SUBJECT: VOGTLE ELECTRIC GENERATING PLANT, UNITS 1 AND 2 – ISSUANCE OF AMENDMENTS REGARDING NUCLEAR SERVICE COOLING WATER FAN OPERATION (TAC NOS. ME7105 AND ME7106)

SAFETY EVALUATION BY THE OFFICE OF NUCLEAR REACTOR REGULATION

VOGTLE ELECTRIC GENERATING PLANT, UNITS 1 AND 2

DOCKET NOS. 50-424 AND 50-425

Figure 3.7.9-1
Required Number of Fans/Spray Cells

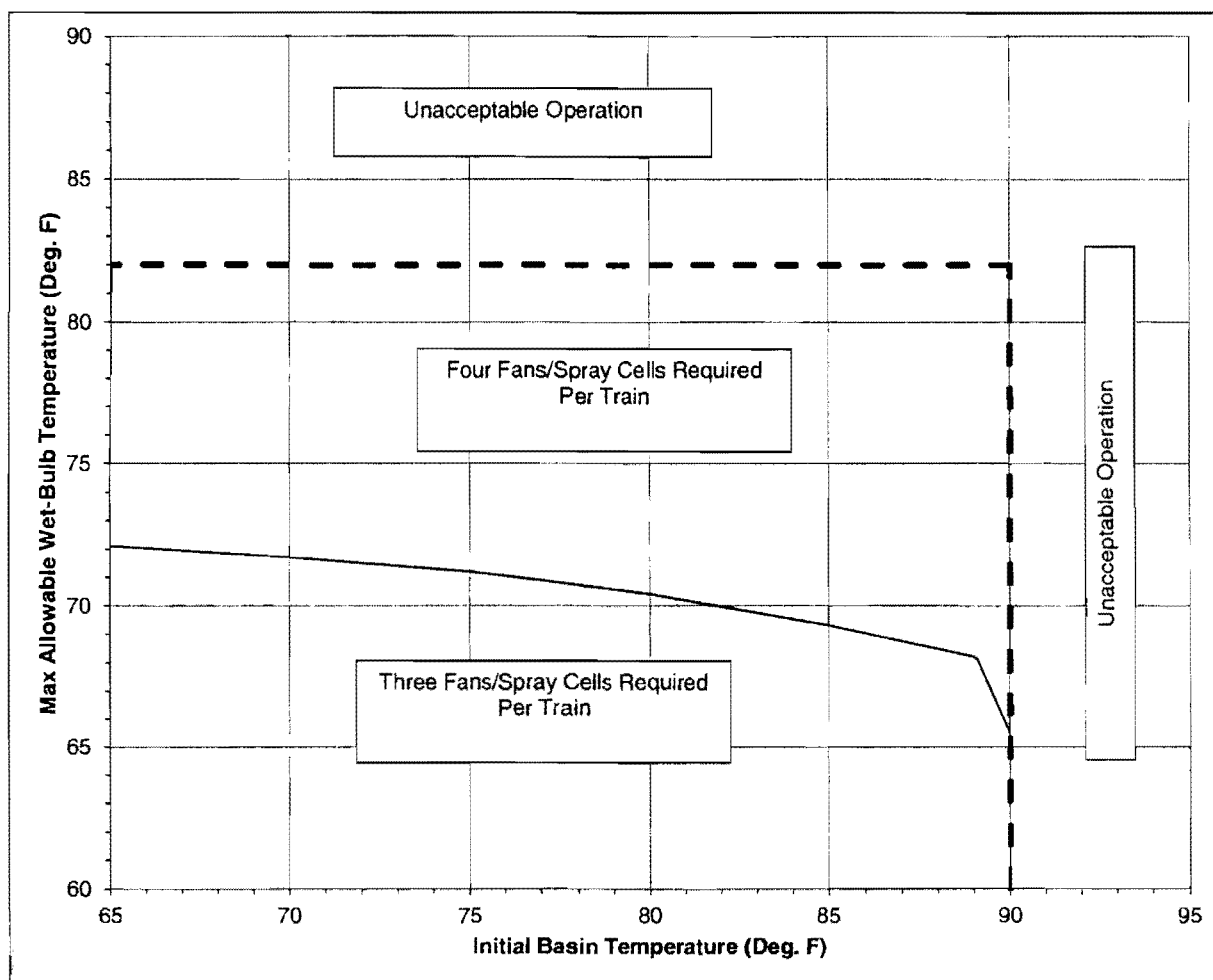
The LCO is revised to state, "The UHS shall be OPERABLE. The fans/spray cells shall be as specified in Figure 3.7.9-1." This proposed change is the result of revised engineering calculations. Associated with the revised LCO, surveillance SR 3.7.9.5 is to be changed to verify wet bulb temperature is within the three-fan/spray cell region of TS Figure 3.7.9-1 if 1 NSCW tower fan is out of service and the daily high dry bulb temperature is expected to be >48 °F.

The subject of the second change is to add a new Condition B that allows a 7-day CT if one-fan/spray cell is inoperable, only when operating in the four-fan/spray cell required region of proposed TS Figure 3.7.9-1. Other changes consist of alphanumeric changes, such as current TS Condition B being changed to Condition C, and other formatting changes required due to the changes discussed above.

The NRC staff performed a detailed review of the licensee's assumptions, design inputs and methodology and compared the results to design and licensing basis requirements. The licensee performed a design basis analysis [Calculation X4C1202S31] to determine the number of NSCW cooling tower fans that would be required to mitigate a DBA (LOCA with LOSP and single failure) at various ambient wet-bulb temperatures and NSCW initial basin temperatures. The design basis calculation accounts for one cooling tower to completely fail (due to LOSP with a single failure loss of a diesel generator). The design basis calculation determined that with ambient wet bulb temperatures up to the design 82 °F and initial basin temperature of 90 °F, one cooling tower with four operable fans/cells will prevent the basin temperature from exceeding the maximum allowed value of 95 °F during DBA mitigation. The design calculation also determined maximum wet bulb temperature as a function of initial basin temperature such that the maximum allowed basin temperature will not be exceeded when operating with one cooling tower having three operable fans/cells. The acceptance criterion for the analysis was to not exceed the NSCW design temperature of 95 °F in the tower basin during mitigation of the DBA.

Since the maximum initial basin temperature for a given wet bulb ambient temperature to be used in establishing the LCO must meet the acceptance criteria in both the DBA [LOCA with LOSP] and the tornado induced LOSP as shown in the tables above, the most limiting initial basin temperature should be used to establish TS LCO limits. Those limits are represented by the licensee's Figure 3.7.9-1 in their June 14, 2013 letter. Figure 3.7.9-1 combines the results of the design basis calculations for DBA-LOCA and the design basis event (DBE) (tornado induced LOSP and tornado missile strike), i.e., the operating limits for LCO 3.7.9 and its Figure 3.7.9-1 are based on the cases for (a) the worst case LOCA and (b) a LOSP event in conjunction with tornado generated missiles. The combined curve with the most limiting values defines the required number of fans/spray cells for the LCO to prevent basin temperature from exceeding its limit for either a DBA-LOCA or tornado induced LOSP. The revisions in the proposed LCO meet the requirements of GDC 2 and GDC 44 and the guidelines of RG 1.27. In accordance with 10 CFR 50.36, LCO limits for temperature have been established for the UHS basin which supplies NSCW cooling to safety-related components that are essential to mitigate the DBA-LOCA and a tornado induced LOSP.

The NRC staff evaluated the LAR where the subject of the second change is to add a new Condition B that allows a 7-day CT if one fan/spray cell is inoperable, only when operating in the four-fan/spray cell required region of proposed TS Figure 3.7.9-1. The existing TS do not allow a required fan to be inoperable for more than 72 hours before action is required to commence shutdown. The subject of the LAR is to add a new Condition B that allows a seven-day CT if one fan/spray cell is inoperable, only when operating in the four-fan/spray cell required region of proposed TS Figure 3.7.9-1. The licensee has stated that repair of NSCW fans challenges the current 72-hour CT. Fan maintenance often requires staging and crane service possibly in inclement weather. Repair efforts in the past have challenged the current 72-hour CT. The licensee has taken steps to avoid unplanned maintenance by enhanced preventive maintenance including a) replacing gearbox oil and inspecting output shafts for backlash, b) replacing fan gearboxes based on runtime, c) installation of vibration monitoring equipment for early warning. The licensee has proposed compensatory measures to be in effect before Condition B is entered. The compensatory measures include:

The required numbers of fans/spray cells are a function of initial basin temperature and the maximum allowable ambient wet bulb temperature and are specified in Figure 3.7.9-1. The staff finds the limits specified in the new Figure 3.7.9-1 to be acceptable. The staff has also reviewed the licensee's proposal to extend the CT of one inoperable fan from 72-hours to 7-days when operating in the four-fan region of new Figure 3.7.9-1. Based on the licensee's compensatory actions specified in the technical evaluation above, the low probability of a DBA during the extended CT, and the moderate increase in basin temperature, the staff finds the licensee's proposed increase in CT identified in new Condition B to be acceptable.

LCO 3.7.9 The UHS shall be OPERABLE. The fans/spray cells shall be as specified in Figure 3.7.9-1.
